System	Date of Issue	Bulletin Number	Bulletin Type
Odyne Systems G2V2.01	11/3/16	00032	<input checked="" type="checkbox"/> Field Service Action <input type="checkbox"/> Technical Service Bulletin <input type="checkbox"/> Technical Service Advisory

Title: TCM PTO Drive Interface

Transmission Control Module

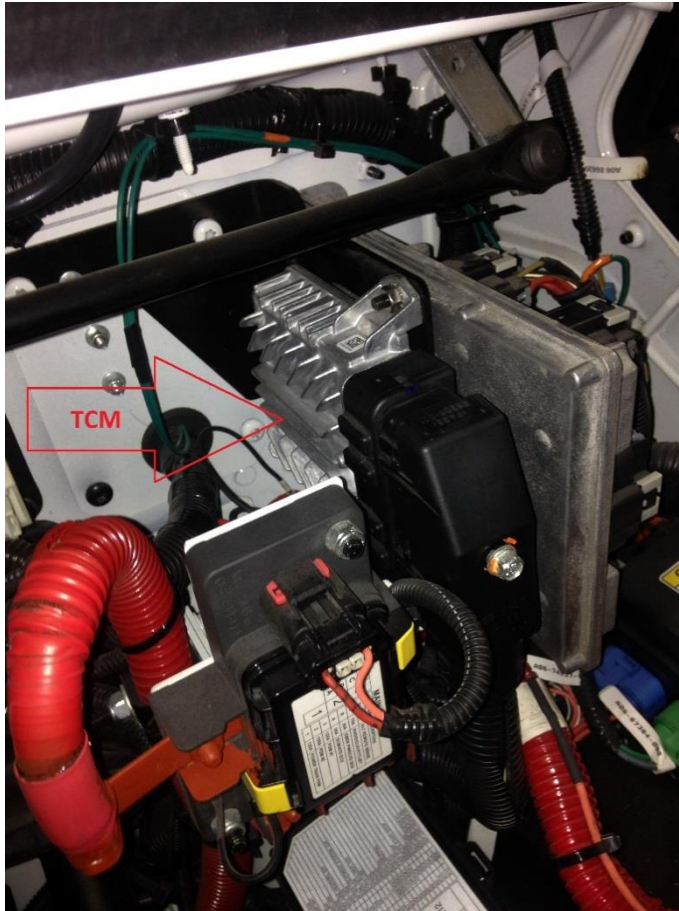
Issue: Transmission main pressure may fall below the minimum required by the PTO clutch control, potentially resulting in PTO clutch failure.

Action: Wire PTO enable signal to pin 43 on TCM.

1. Locate the TCM on the chassis.

2. Remove the TCM connector.
3. Crimp Odyne part number 20727 or Allison equivalent terminal onto a 14-16AWG wire that is long enough to reach the PTO.
4. Install the terminal into cavity 43 on the TCM connector.

5. Reinstall the TCM connector.
6. Install a split loom over the wire and route to the PTO. Be sure to secure loom so that it does not come into contact with any moving parts.
7. Locate the Odyne J32 connector near the PTO.
8. Using solder and adhesive lined heat shrink, splice the wire coming from TCM cavity 43 into the wire coming from J32 cavity A.
